ADDENDUM #2 DATE: 09.22.2022

PROJECT MANUAL FOR:	CP221951 UMPB Ground Floor Renovation
ADVERTISEMENT DATE:	08.29.2022
PREPARED FOR:	The Curators of the University of Missouri
CONSULTANTS:	CP221951 bc DESIGN GROUP 12101 110th Street, Suite 100 Overland Park, KS 66210 913.232.2123 x 809

PROJECT:	UPMB Ground Floor Renovations
PROJECT NO:	MUHC – CP221951, R&B - 1202.0011414.000
DATE:	September 22, 2022
BY:	Tori Gillespie
RE:	Addendum #2
DWG REF:	See below
SPEC REF:	See below
CC:	Central File
SPEC REF:	See below

$2 \log voltage responsibility matrix$

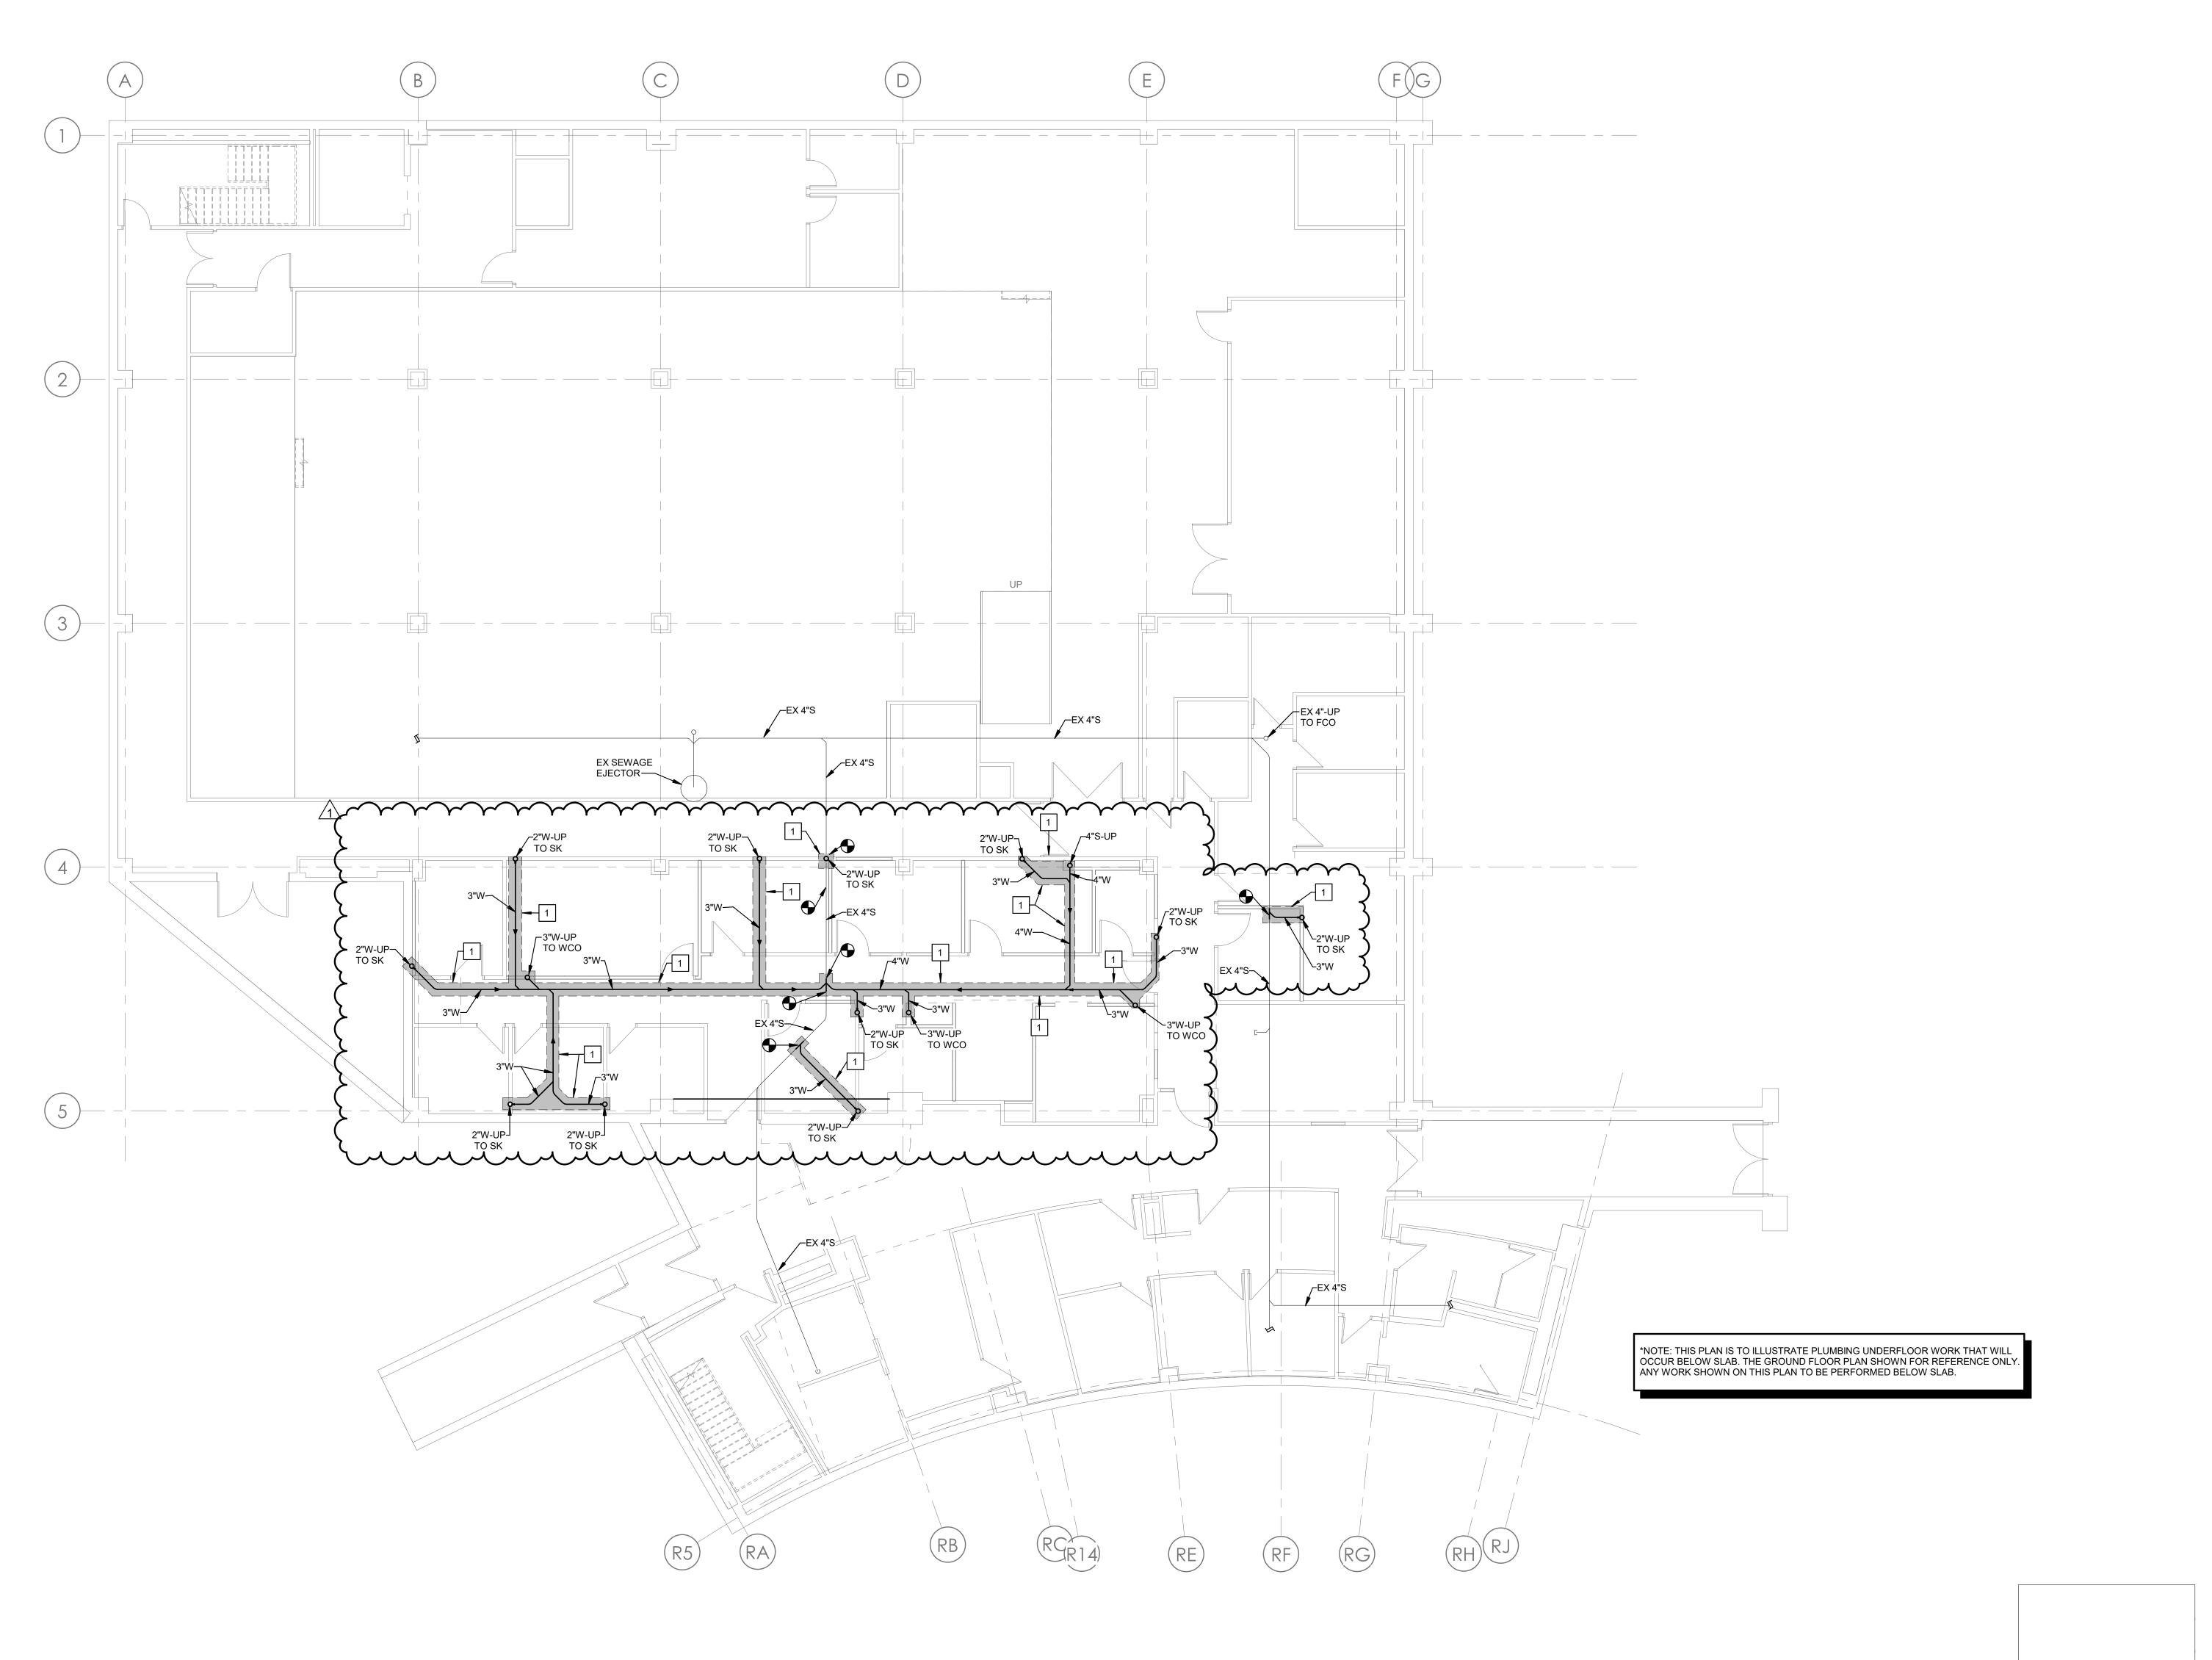
- Sheet E100 low voltage responsibility matrix. The telecom and the CATV call out for the outlet faceplates and terminations to be Furnished and Installed by the contractor. Typically these are by the owner here at MU. Please review and clarify if the notes are correct, or will need to be corrected in an addendum.

- 1. E100
 - a. REVISE the low voltage responsibility matrix

- a. Low Voltage responsibility matrix has been revised for this addendum.
- 3. Also, sound masking is listed as Alternate #7, but I don't see it referenced anywhere else on the drawings, and there are no alternates shown on the bid form. Is there any sound masking on this project?

PLUMBING - GROUND FLOOR PLAN

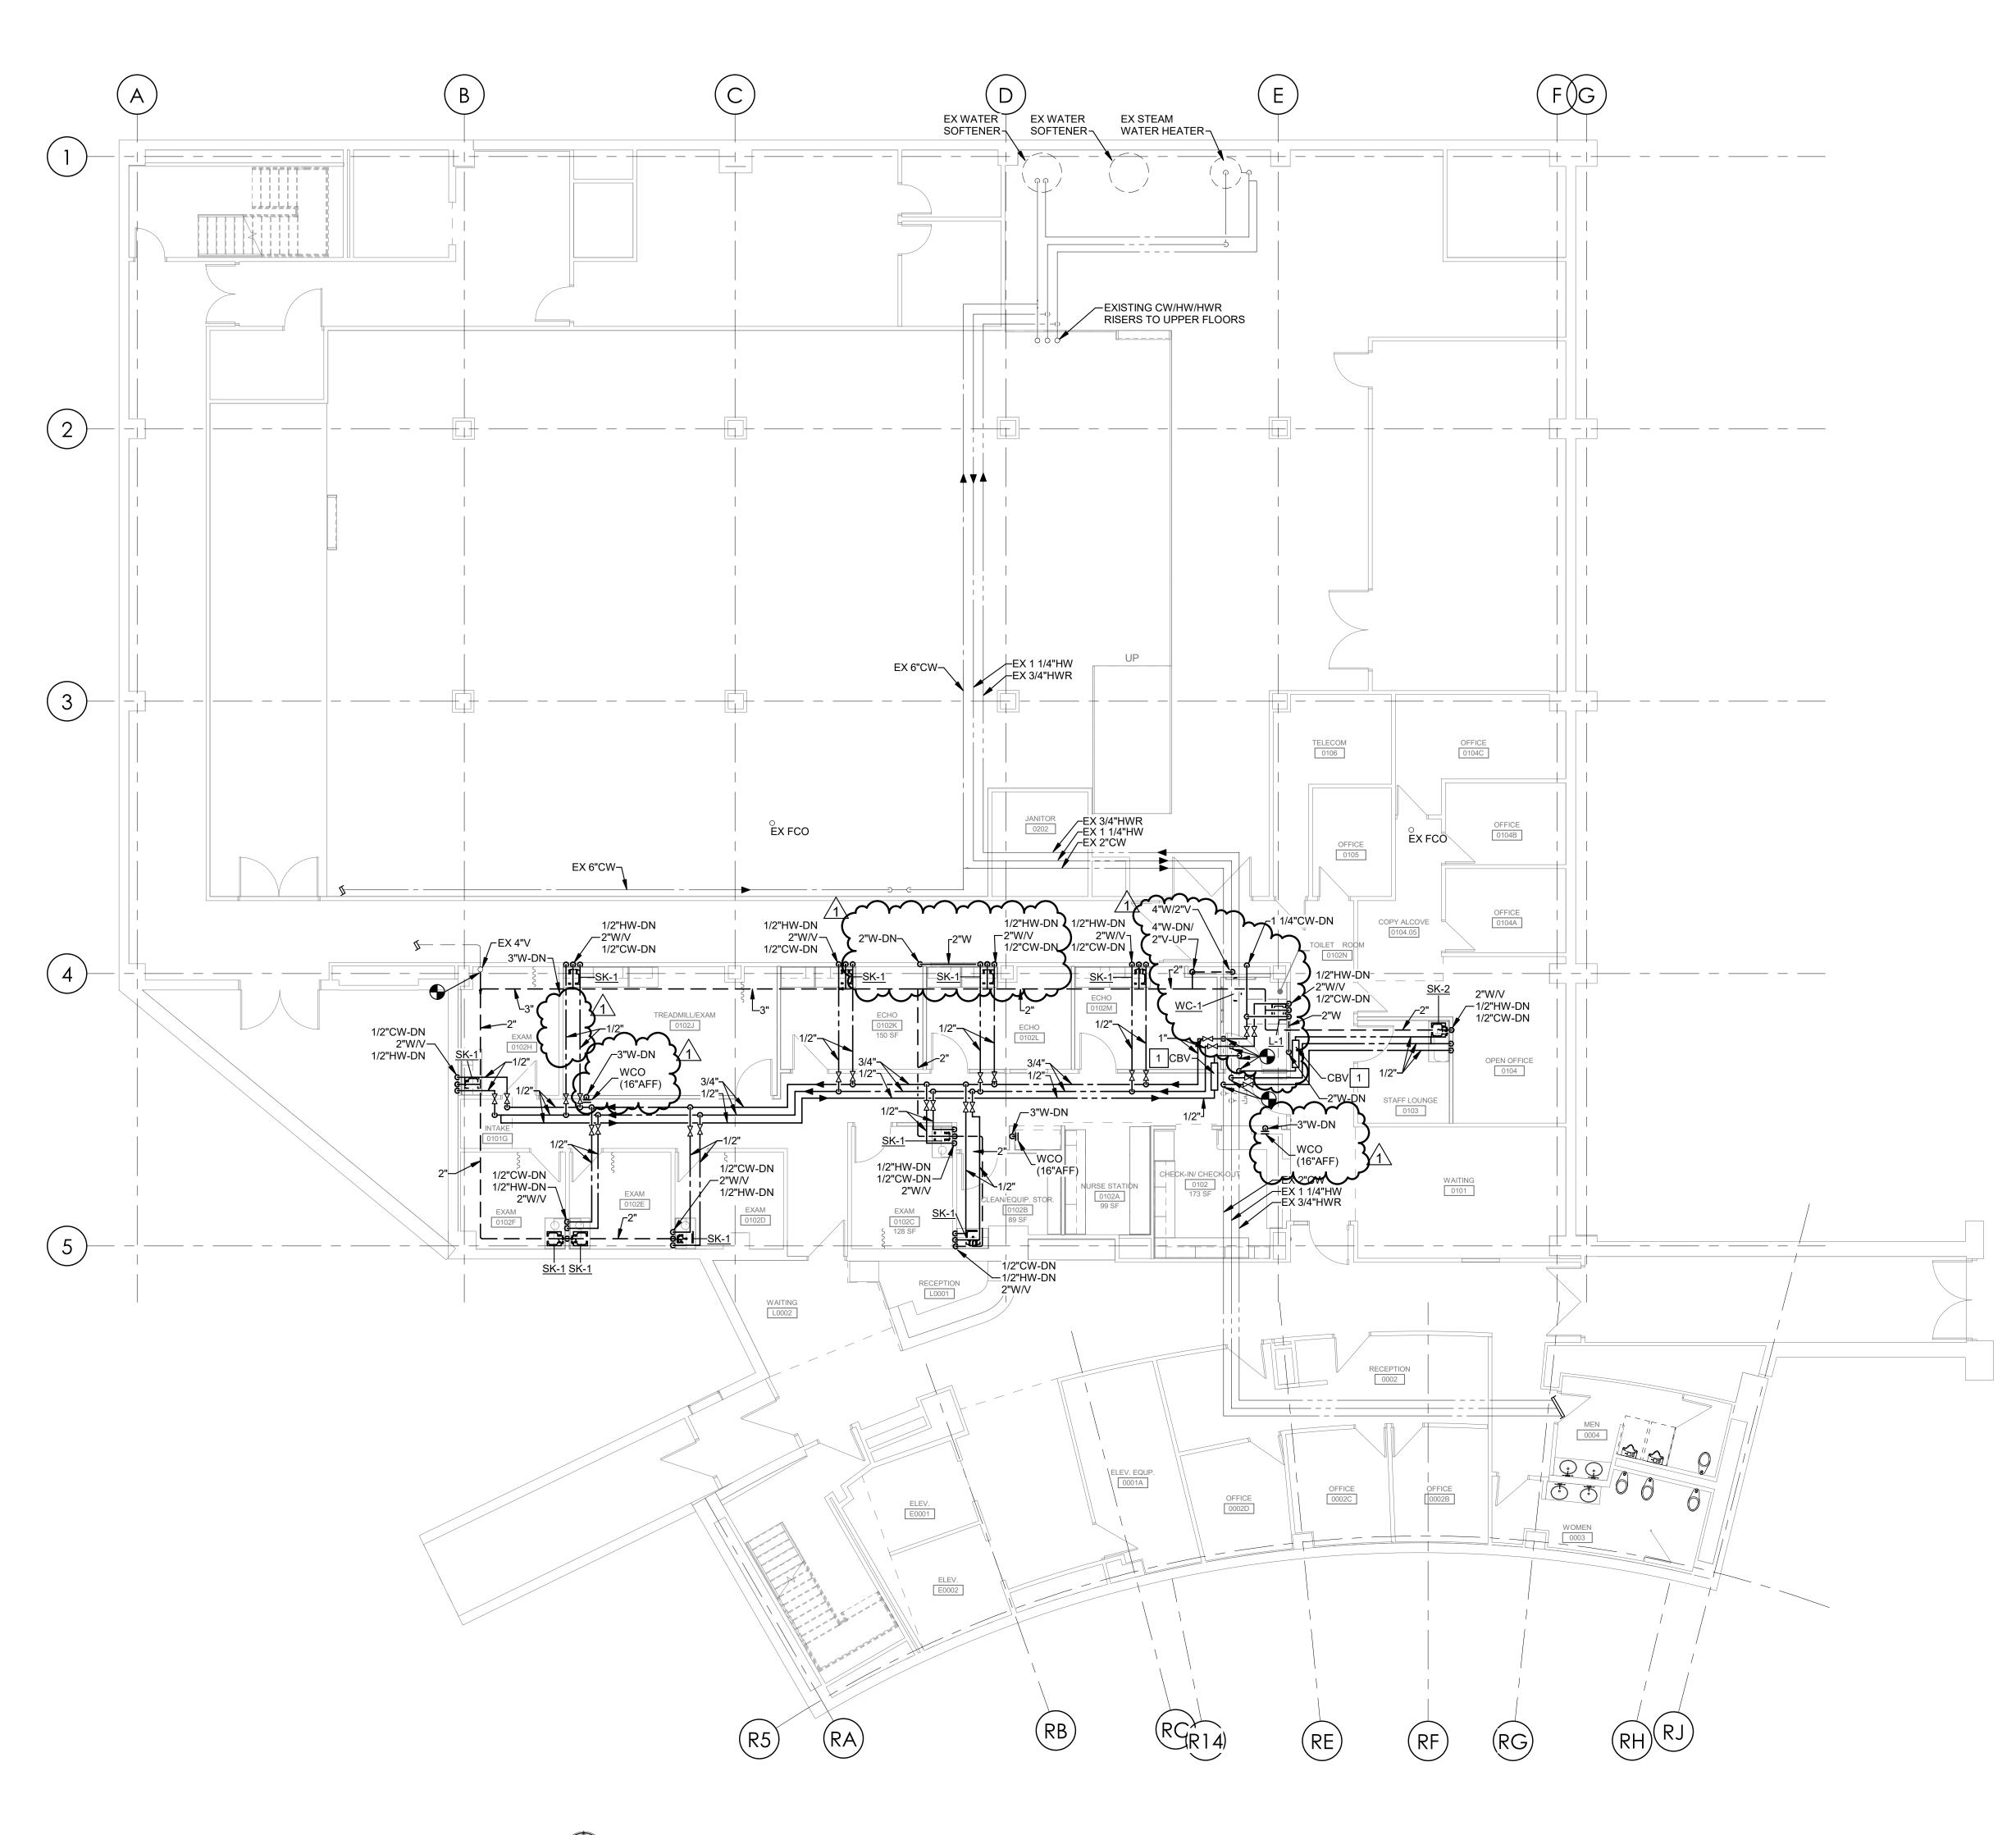
- 1. P100
 - a. REVISE routing of sanitary/waste piping & saw cutting to coordinate with structural footings.
 - b. ADD waste piping for new wall cleanout locations.
- 2. P101
 - a. REVISE sanitary & vent piping for water closet (model was changed to a wall hung unit).
 - b. ADD waste piping for new wall cleanout locations.
 - c. REMOVE two previous wall cleanout locations.
 - d. REVISE waste piping for a sink and lavatory to be routed in wall before dropping below slab to coordinate around structural footings.
- 3. P400
